## PRODUCT INFORMATION SHEET - V8 CYLINDER HEAD GASKETS

UE31004 - UT12890PD - 07V103147

#### Cylinder Head Gaskets (07V103147 - formerly UT12890PD)

## CYLINDER HEAD GASKETS

Fig 3 New Gasket Now Used on ALL Engines (UE 45215)

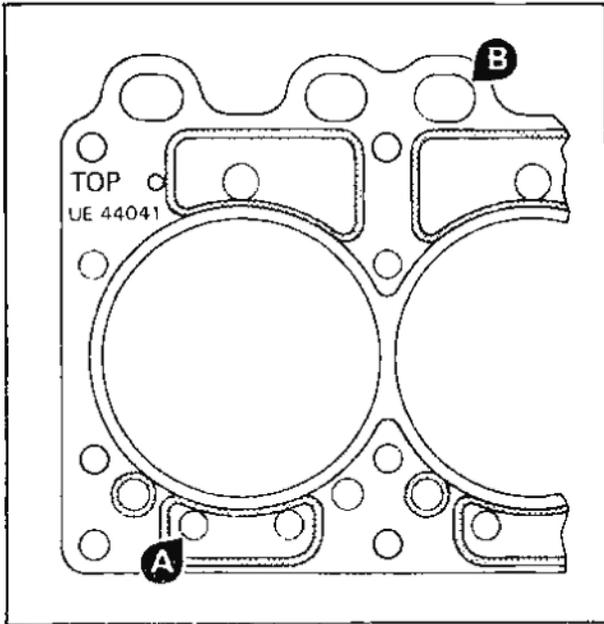
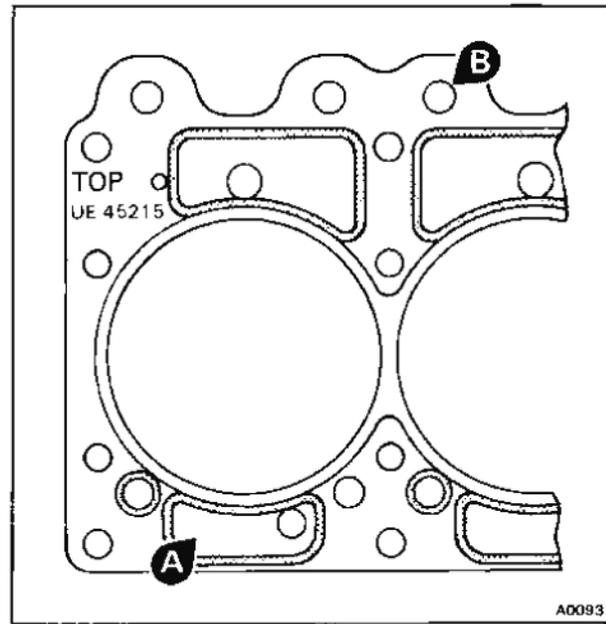
The new cylinder head gasket is similar to that used previously on the Bentley Mulsanne Turbo engine. However, changes have been made to the push rod hole size and one of the coolant hole passages has been deleted (see figs.1 and 3).

- A Two coolant passage holes
- B Size of push rod hole

- A One hole has been deleted
- B Push rod hole decreased in size

The latest gasket (UE 45215) can be used for ALL Bentley Mulsanne Turbo engines, but MUST NOT be used on normally aspirated engines prior to vehicle identification numbers listed above. UE 31004 must be used on all these earlier engines.
